July 12, 2022

RE: JMC Project 20044
4 Tripp Lane Gross Land Coverage Compliance Analysis
4 Tripp Lane
Town of North Castle, New York

Response to Town Consultant's Comments

POOL PAVILLION FLOOR PLAN
SCALE: 1/4" = 1'-0"

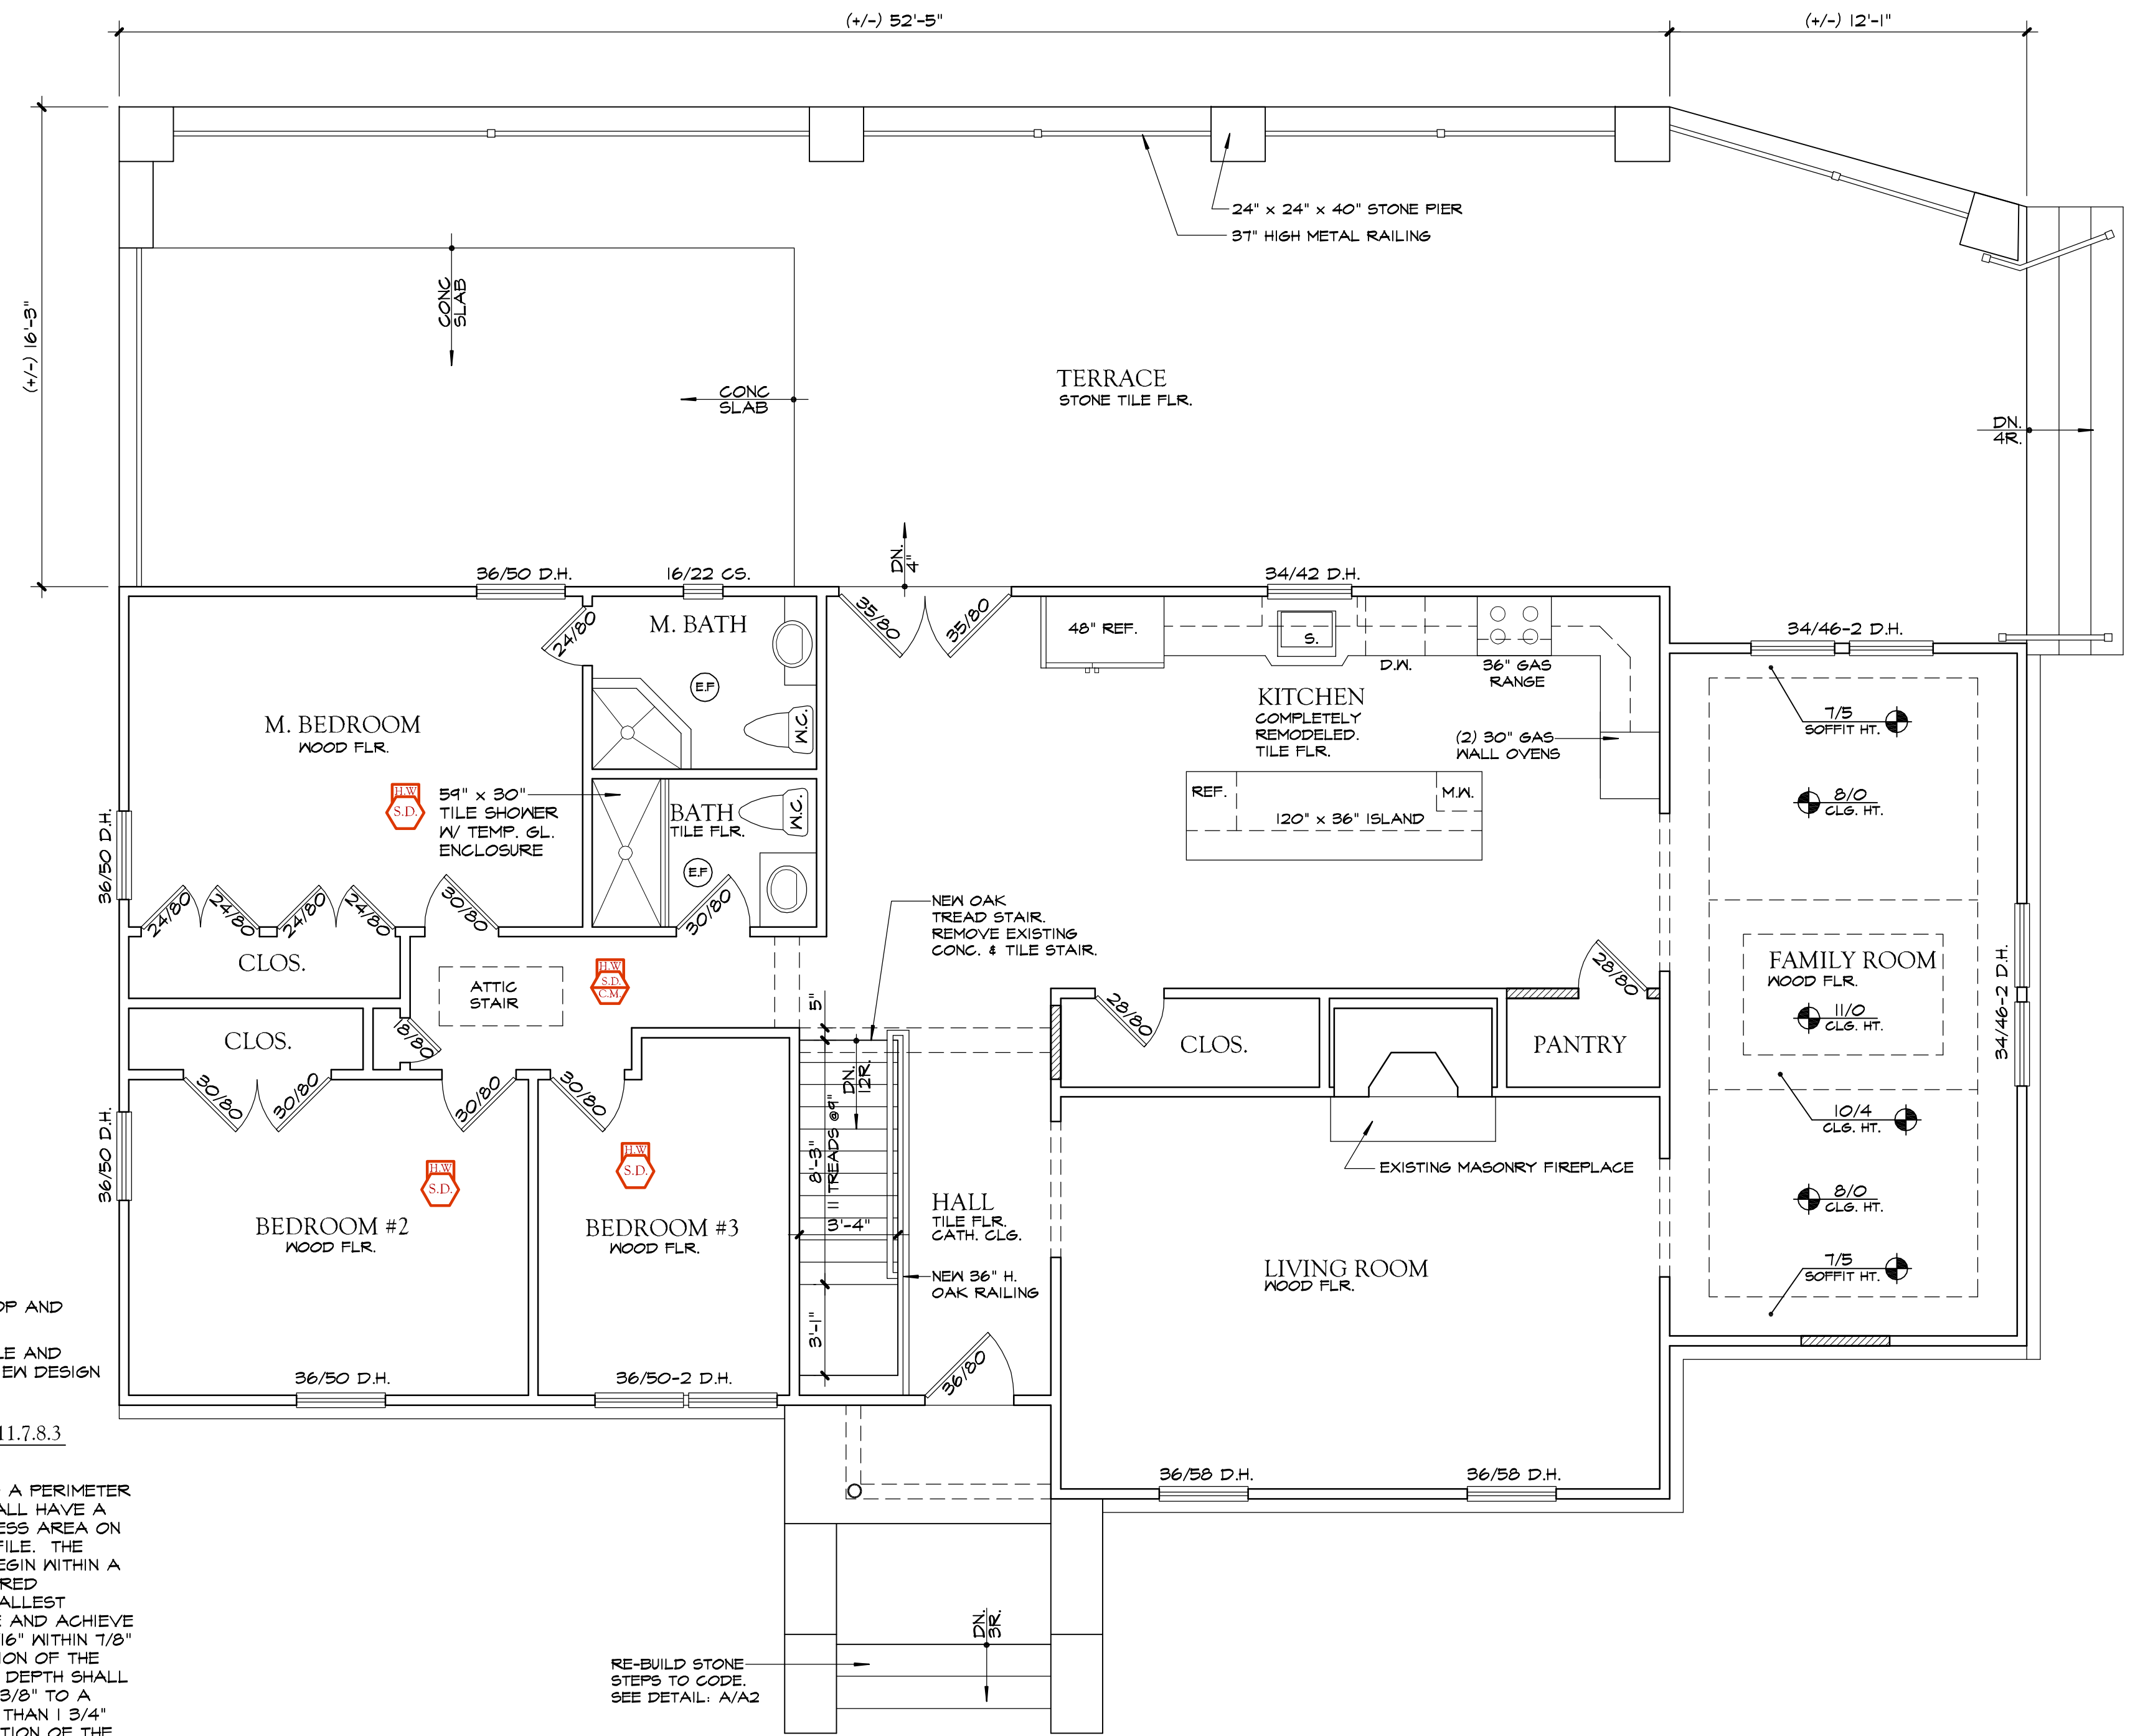
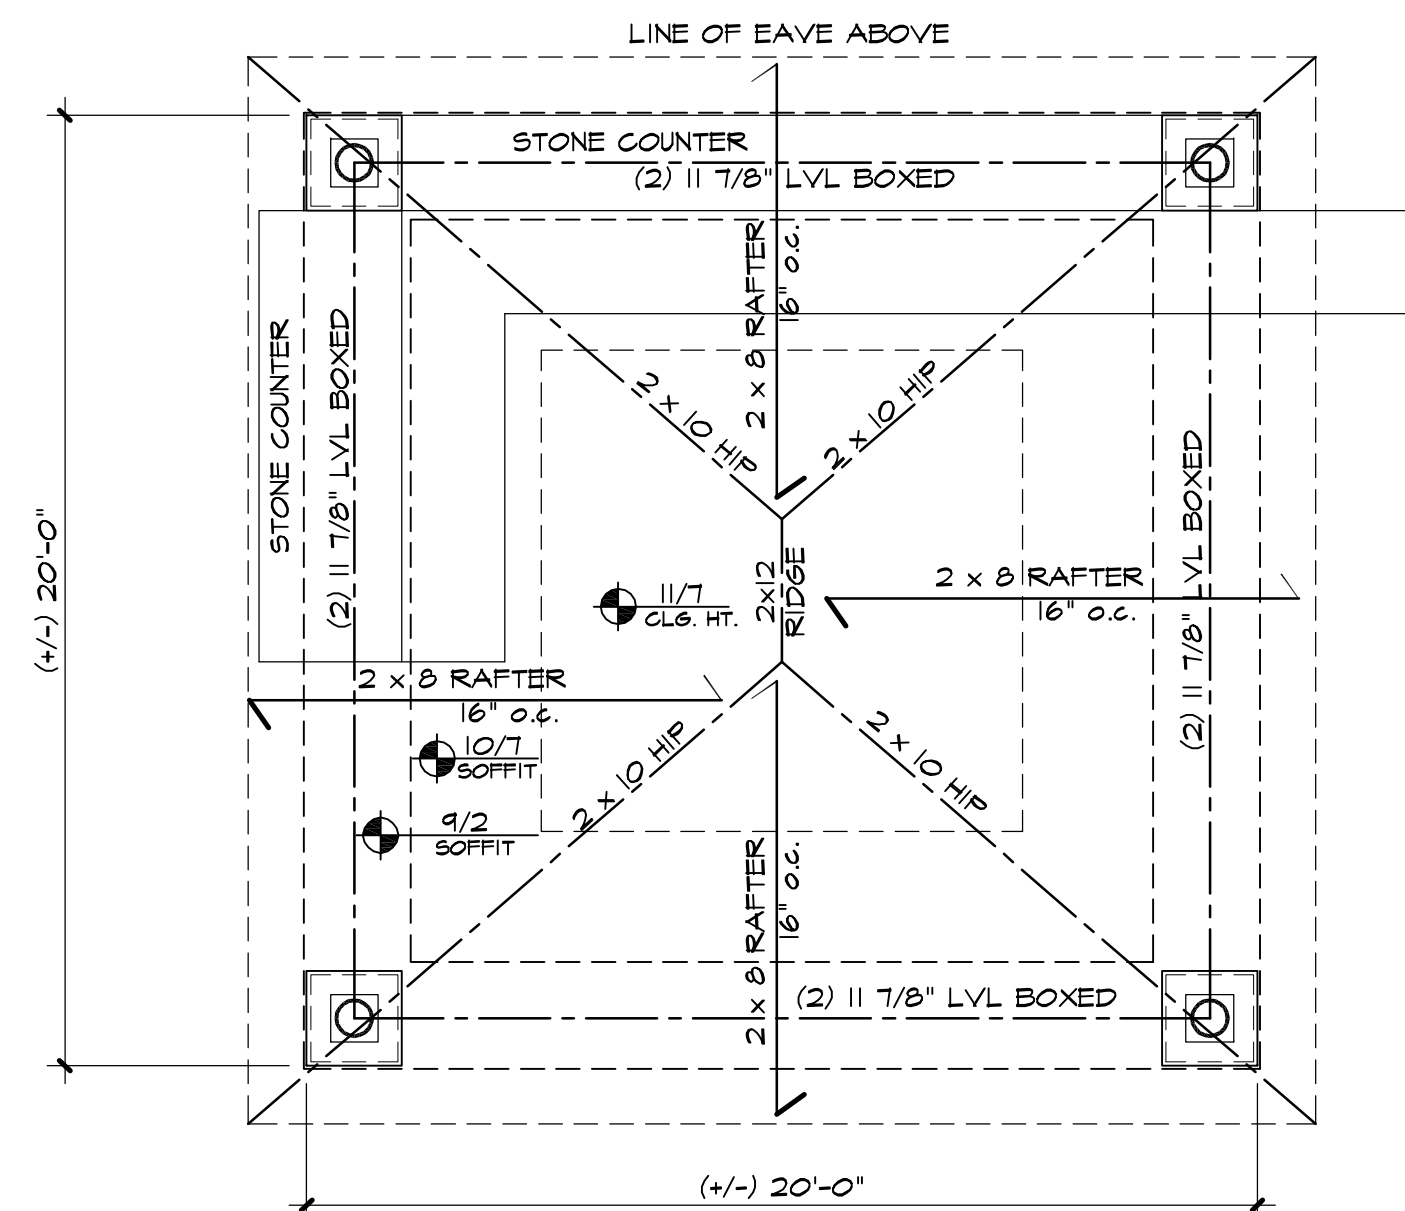
The Applicant should submit floor plans and elevations for the proposed (legalization) cabana.

Floor plans and elevations have been provided for the improvements to the residence along with the Cabana.

Drawn: DK Approved: AN
 Scale: 1" = 20'
 Date: 03/01/2021
 Project No: 20044
 2004-SIE-IX PRE-EXIST PRE-EX COND LS
 Drawing No: **C-100**

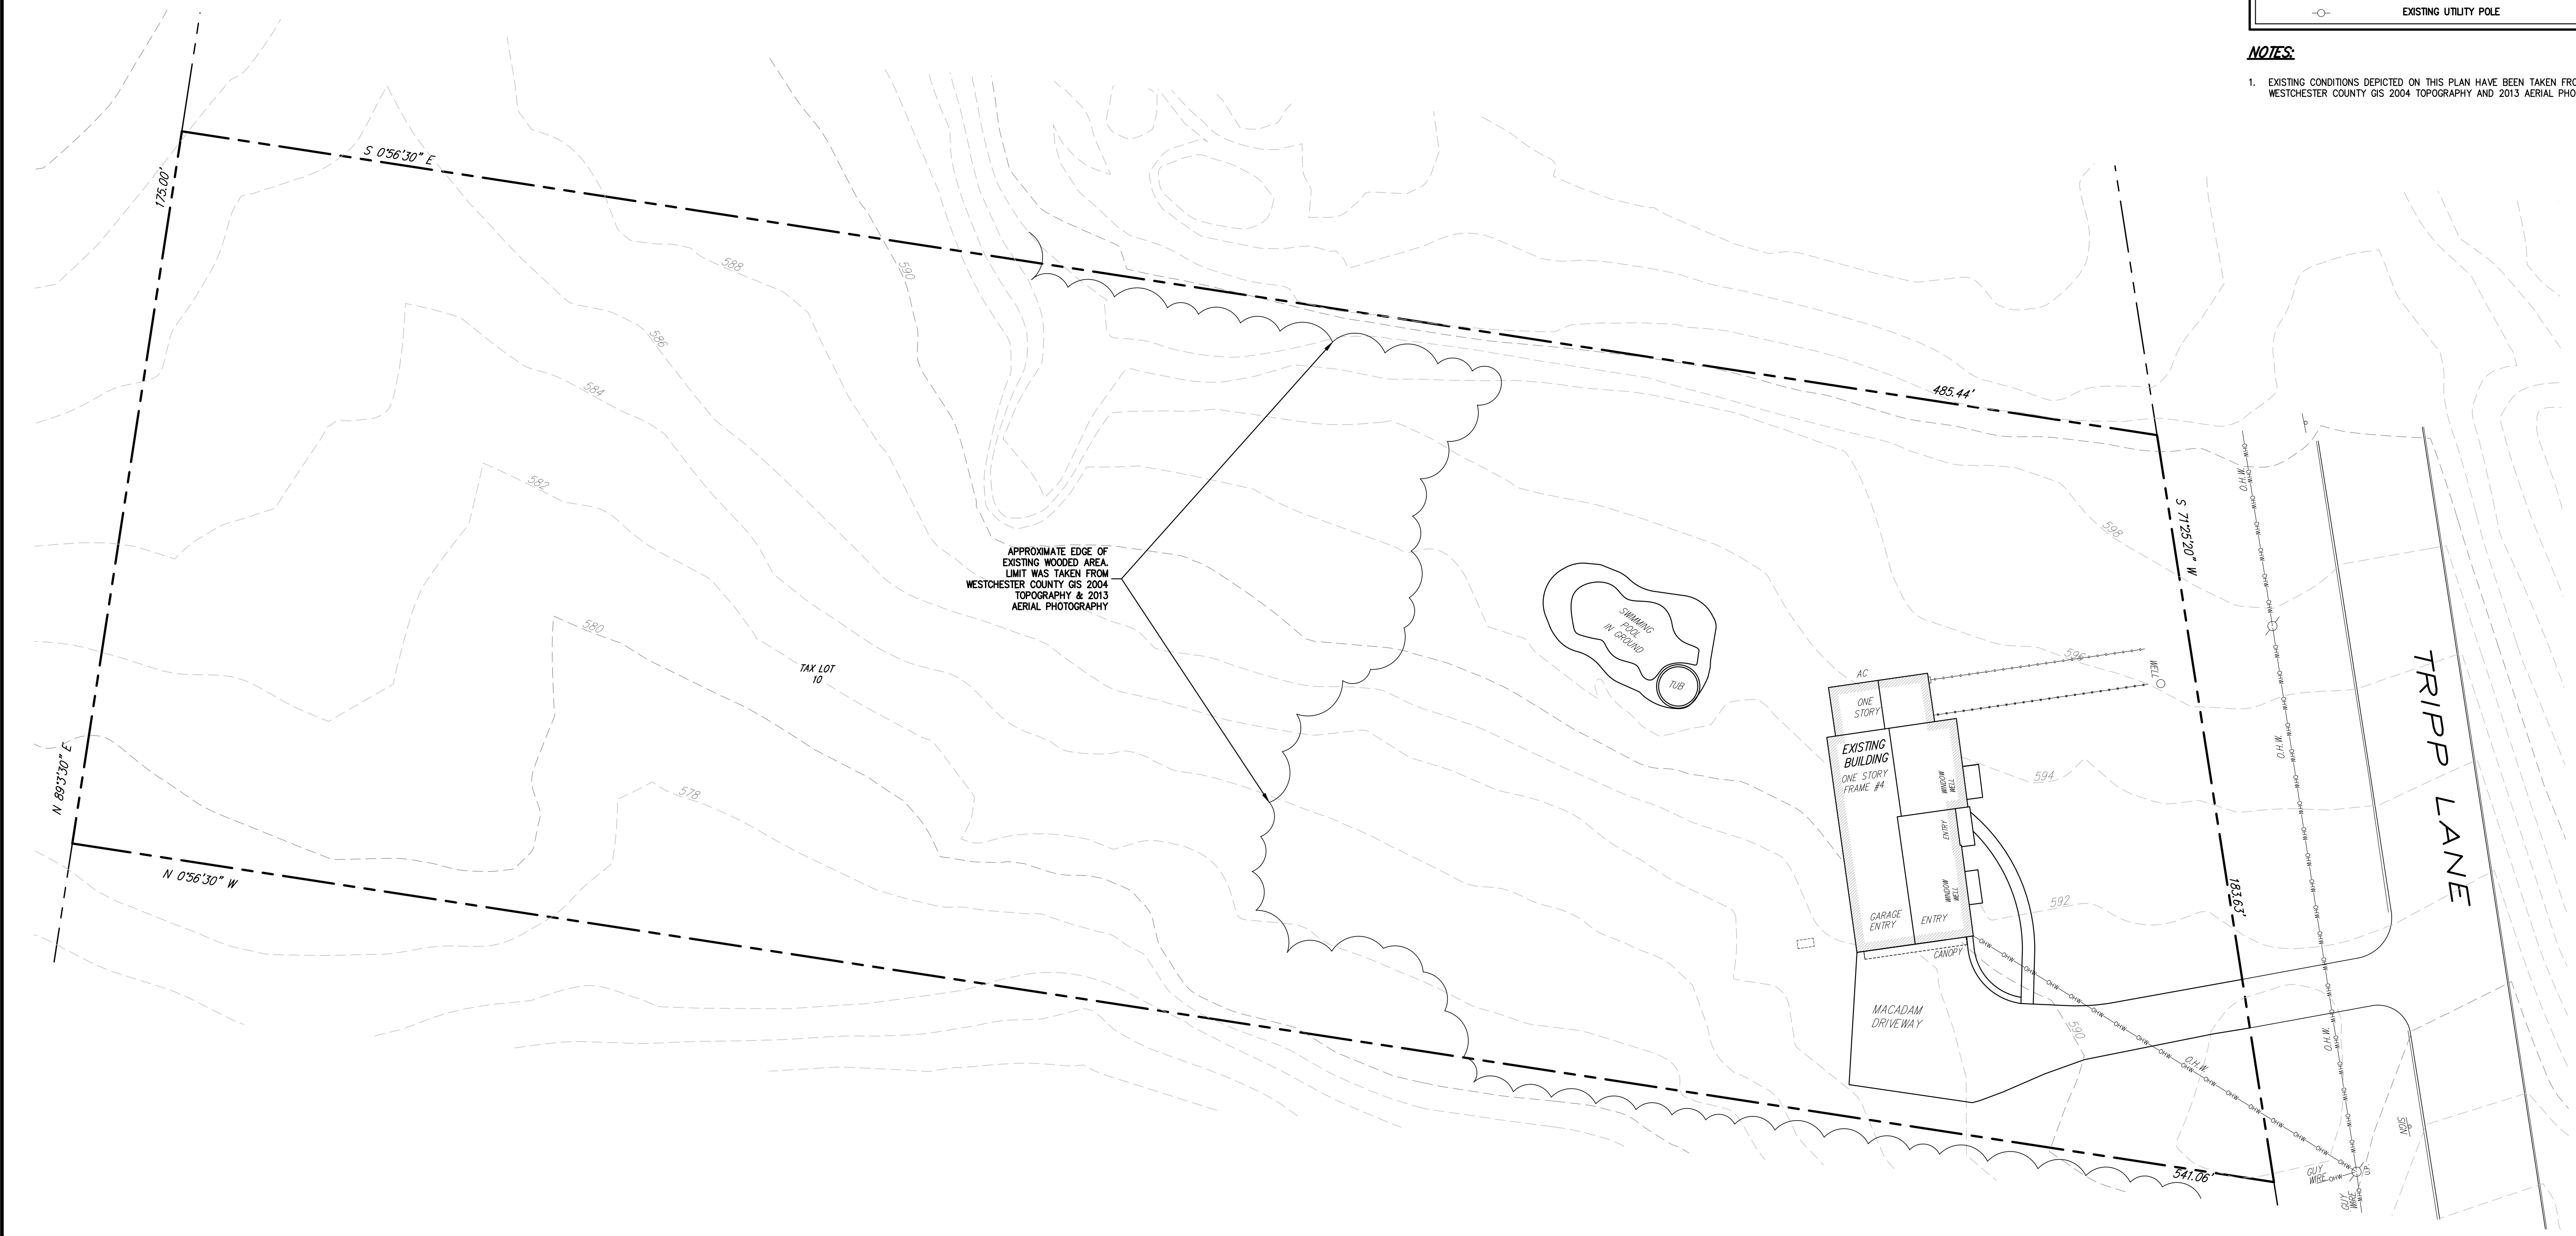
The applicant will need to demonstrate to the Planning Board the levels of disturbances associated with the tree removal, filling and grading, construction of additional structures, walks, walls, patios, etc. This office will require an engineered site plan and comparative plan analysis using available historical Westchester County aerial mapping and GIS topography. This plan shall be used as the baseline to establish the various disturbances and the associated mitigation that will be required.

An engineered site plan depicting the current conditions of the site has been prepared along with a pre-existing conditions plan depicting what the Site had looked like before the owner performed the improvements.
